**ADDENDUM NO. 01 – PORTAGE PUBLIC SCHOOLS – HAVERHILL ELEMENTARY SCHOOL BP 5:  
FOOTINGS AND FOUNDATIONS**

## ADDENDUM NO. 1 [BP 5]

<b>DATE OF ISSUANCE:</b>	June 15, 2023
<b>PROJECT:</b>	<b>Haverhill Elementary School Bid Package 5: Footings and Foundations</b> 6633 Haverhill Avenue Portage, MI 49024
<b>OWNER:</b>	Portage Public Schools
<b>ARCHITECT'S PROJECT NO.:</b>	21-237.25
<b>ORIGINAL BID ISSUE DATE:</b>	May 25, 2023

**4** GATHERING STAIR SECTION  
 3/4" = 1'-0"

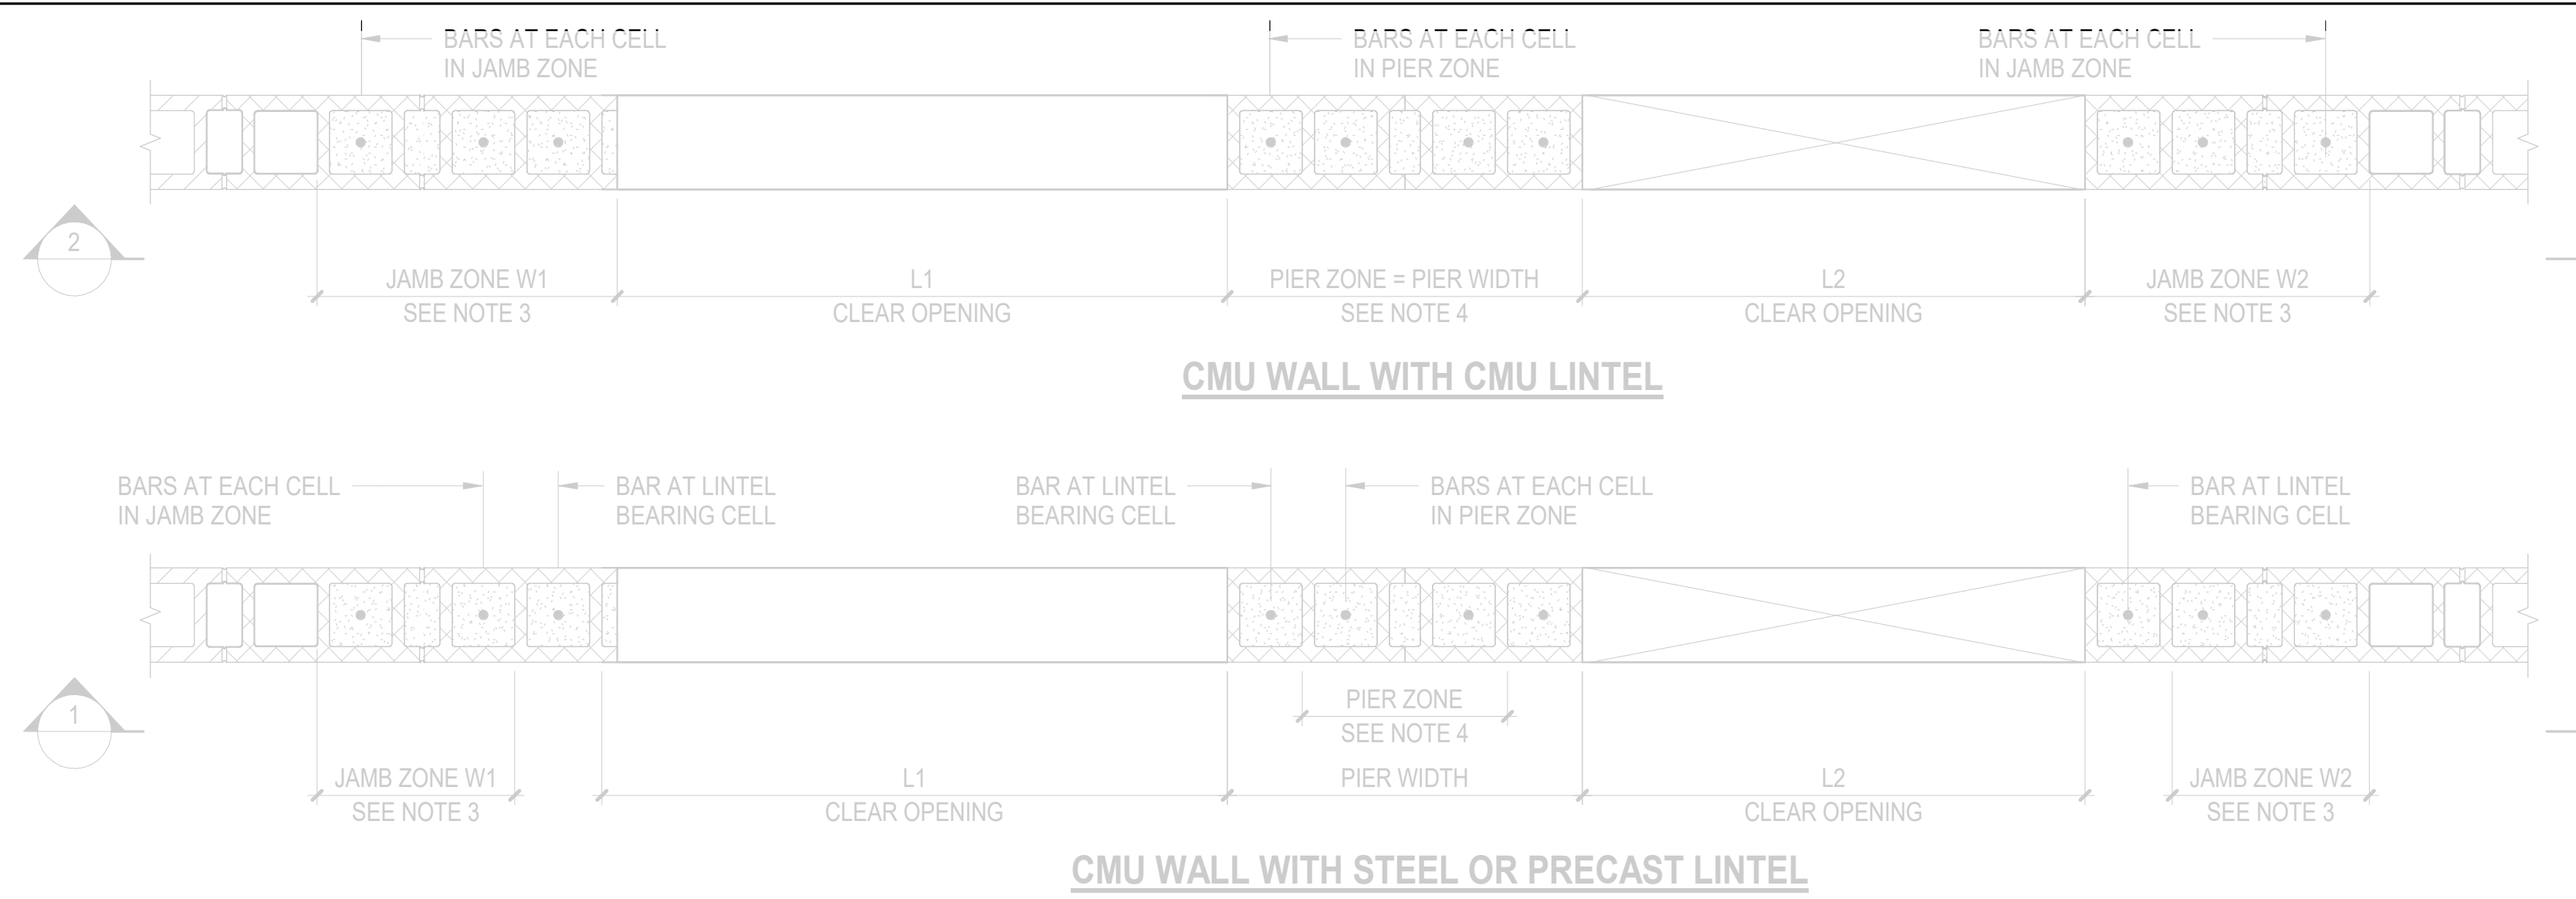
Refer to Sheet(s): S212

- updated footing geometry at gathering stair footings
- Shifted gathering stairs to match arch

SHEET NUMBER  
**S 600**  
 21-237.25

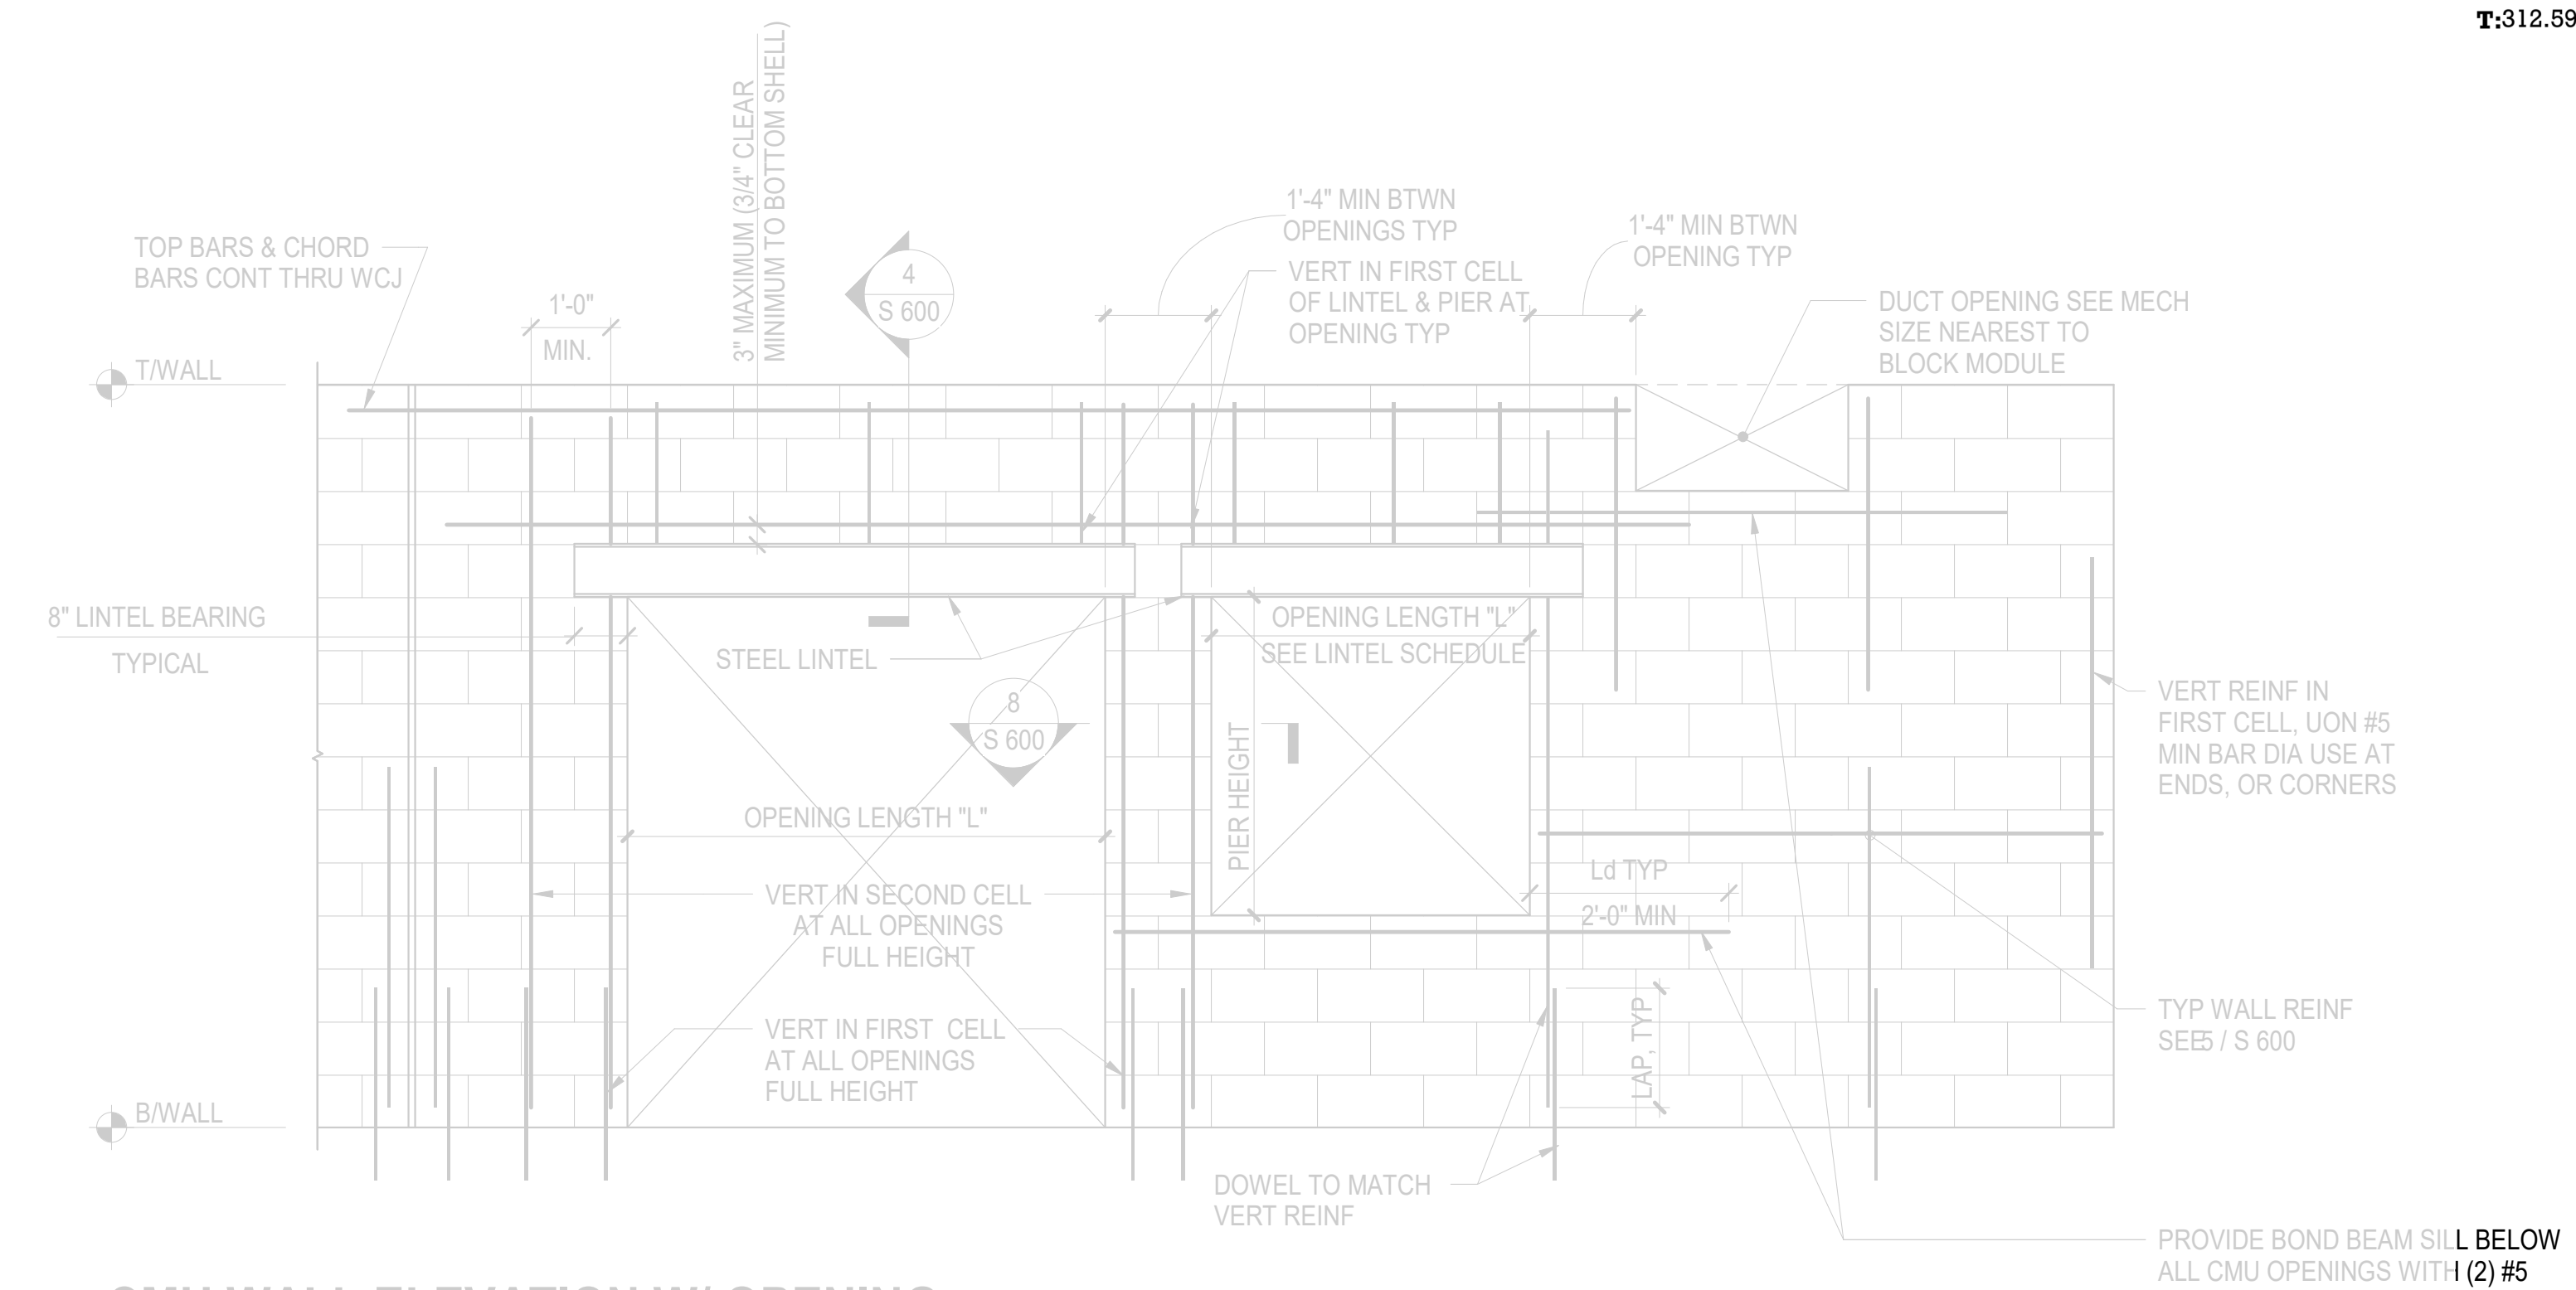
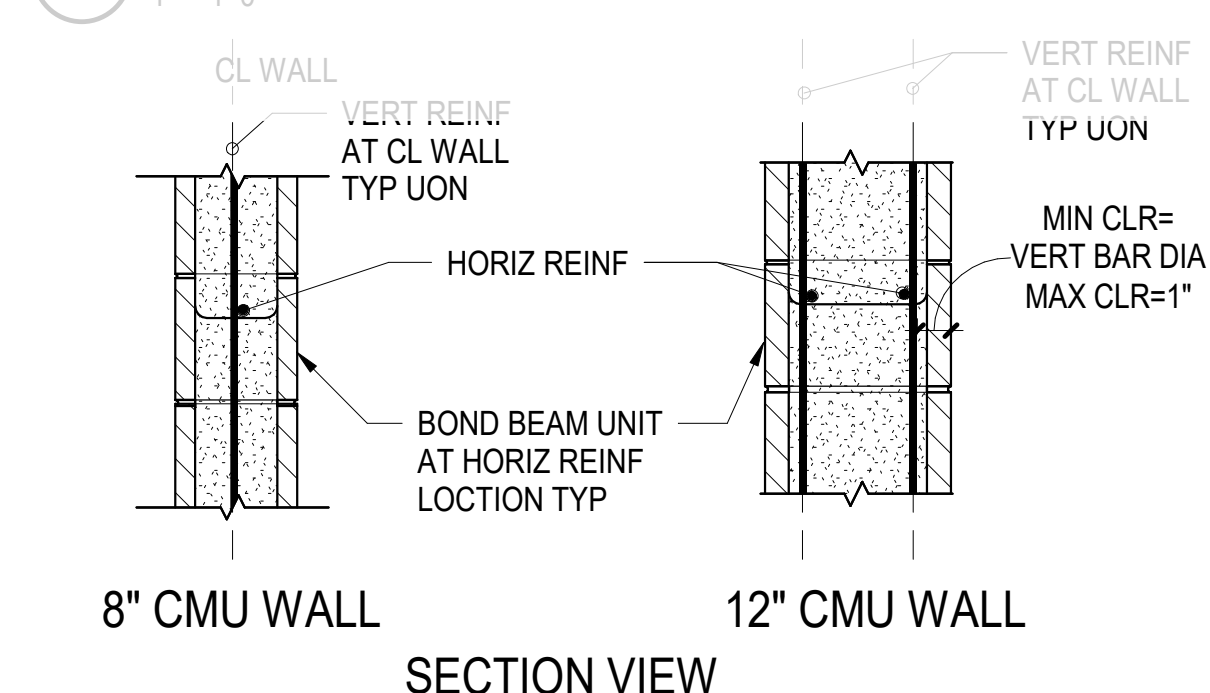
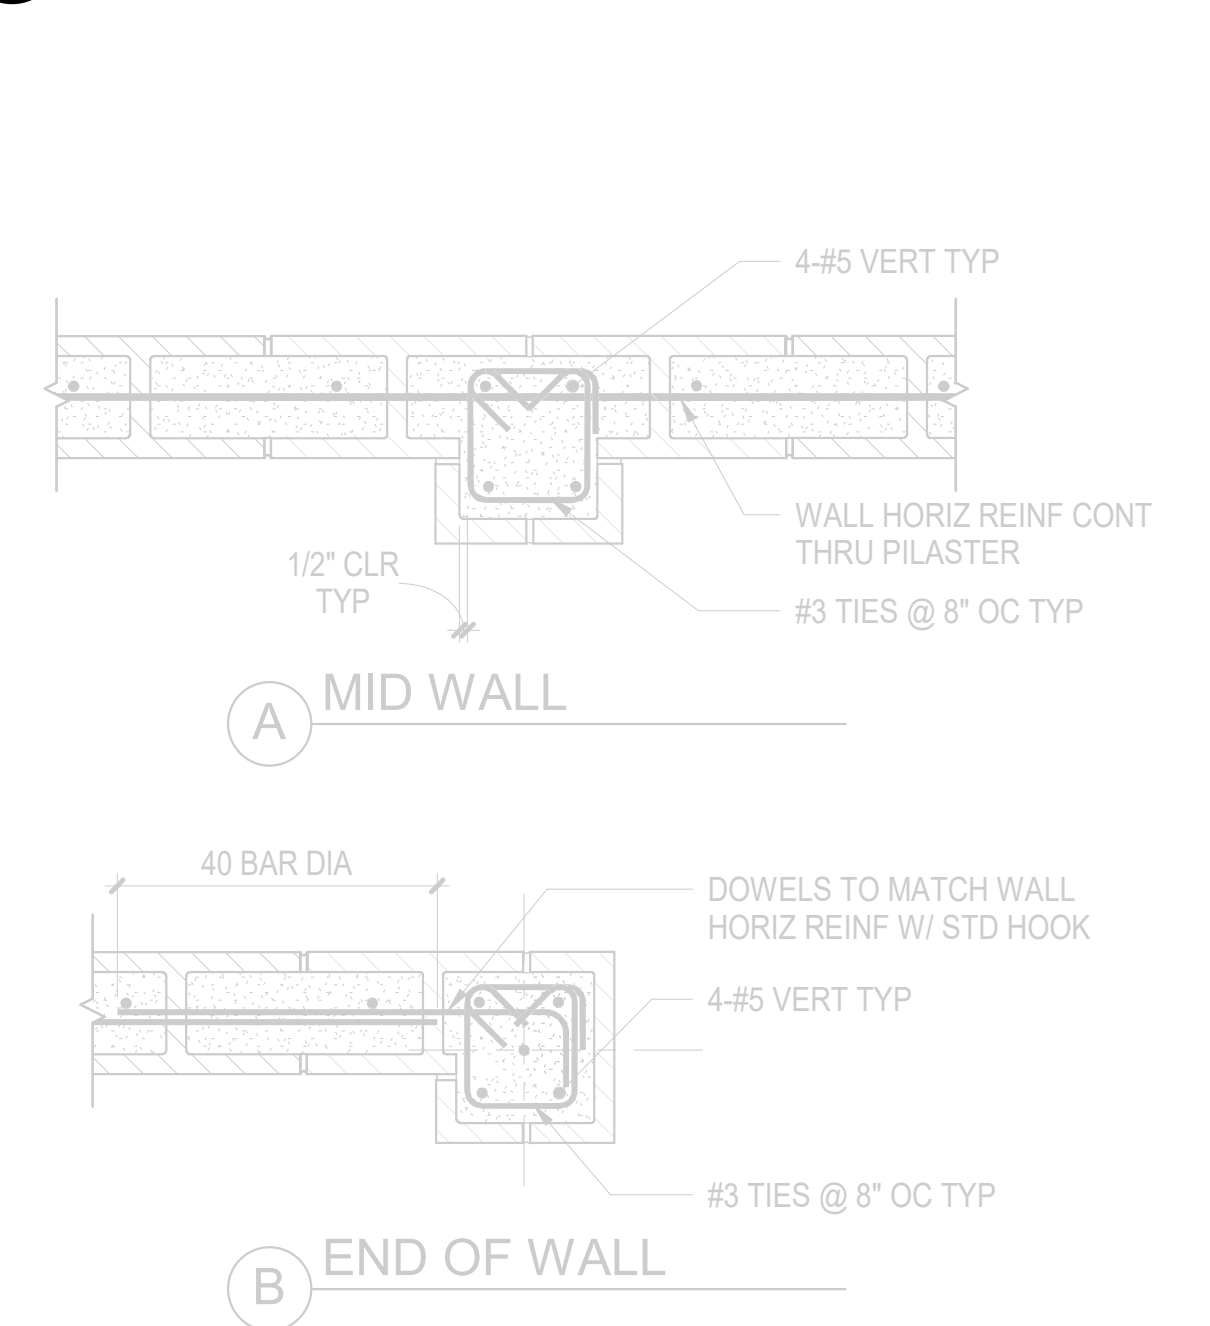
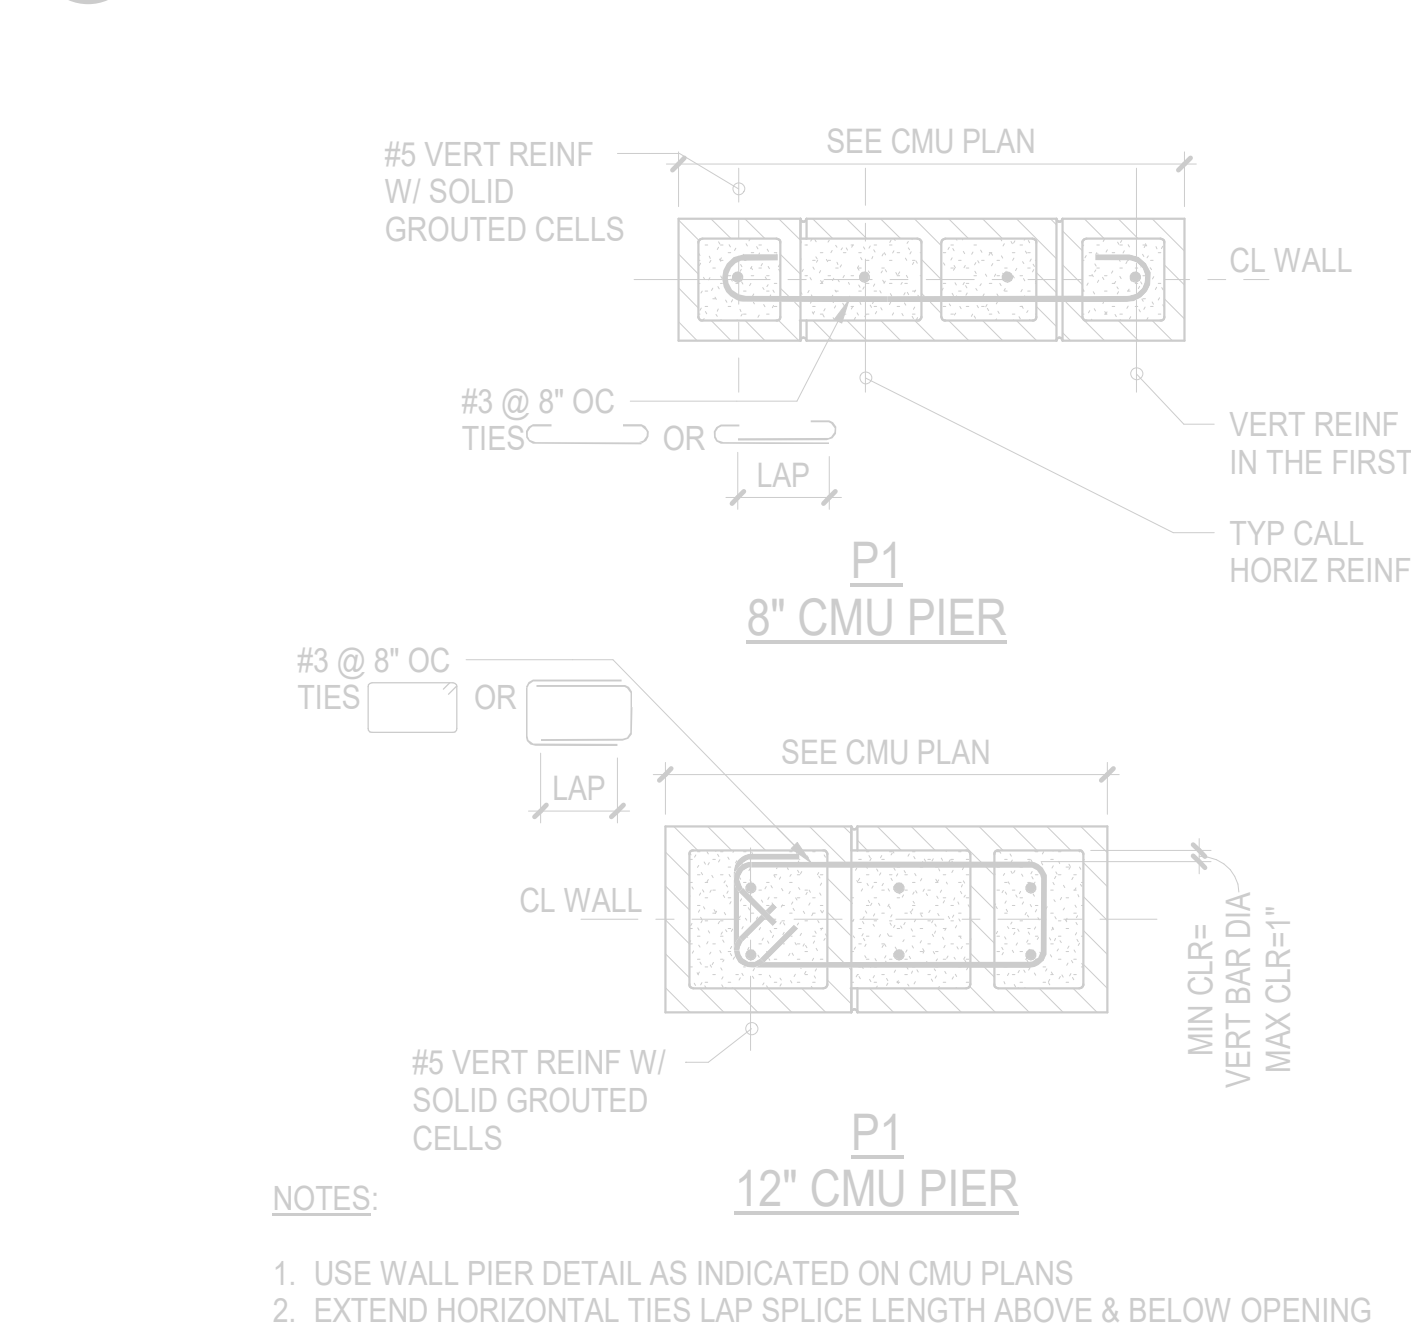
Refer to Sheet(s): S600 [for reference only]

- Clarified CMU wall type and reinforcement schedule
